UNITED STATES PATENT AND TRADEMARK OFFICE

APPLICATION NO.	FILING DATE	FIRST NAMED INVENTOR	ATTORNEY DOCKET NO.	CONFIRMATION NO.
10/786,486	02/25/2004	Ronald W. Ausen	58196US007	3119
32692	7590	06/15/2005	EXAMINER	
3M INNOVATIVE PROPERTIES COMPANY PO BOX 33427 ST. PAUL, MN 55133-3427			SANDY, ROBERT JOHN	
			ART UNIT	PAPER NUMBER
			3677

Office Action Summary	Application No. 10/786,486	Applicant(s) AUSEN ET AL.	
	Examiner Robert J. Sandy	Art Unit 3677

DETAILED ACTION

**FIG. 1****FIG. 2****FIG. 5**

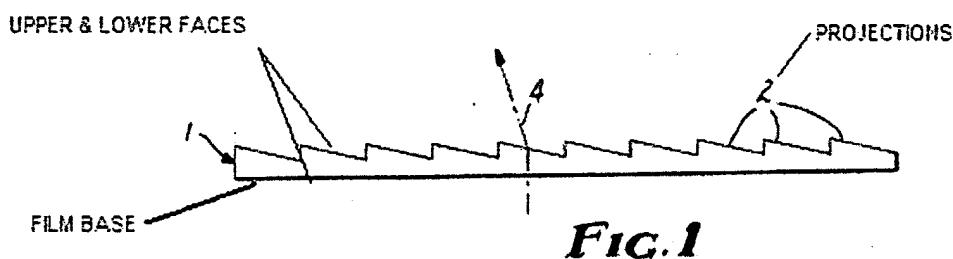
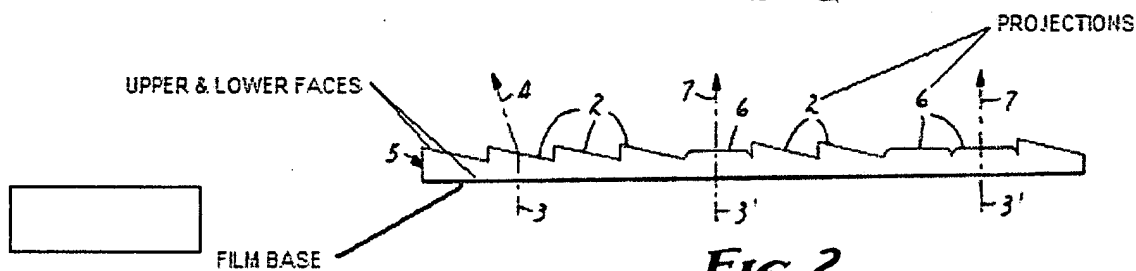
Claim 1 is rejected under 35 U.S.C. 102(b) as being anticipated by Brady, Jr. (U. S. Patent No. 4,497,860). Brady, Jr. ('860) discloses a unitary film structure (Figs. 1, 2 and 5 have been provided herein) of a polymeric resin (see description of "Suitable polymers" in the paragraph beginning as col. 2, line 41) comprising a film base (see Figs. 1, 2 & 5; 18) having generally parallel upper and lower faces and having projections (2, 6, 19) being arranged in rows (The figures show and are described as "a support layer (18) and prisms (19) in linear array.") with at least 25 spaced projections (peaks of prisms) per centimeter in a row projecting from at least the upper surface of said base.

Brady, Jr. ('860) meets the limitation of "projections being arranged in rows with at least 25 spaced projections per centimeter in a row" where Brady, Jr. ('860) describes the periodicity (i.e., space between the peaks of the prisms) in column 4, lines 14-15, as "Generally the periodicity should be between 25 to 1000 microns (1 to 40 prisms per mm)". Brady, Jr.'s range of "1 to 40 prisms per mm" is equal to 10 to 400 prisms per cm (i.e., 1 to 40 prisms per mm

multiplied by 10 mm per 1 cm results in 10 to 400 prisms per cm) which encompasses the claimed lower limit of "at least 25 spaced projections per centimeter. Brady, Jr. ('860) also meets these limitations as the gratings 26 (shown in Fig. 6) are described wherein "[th]e gratings (26) can be 150 to 1500 lines per mm." where the gratings are projections linearly spaced 1500 to 15,000 per cm.
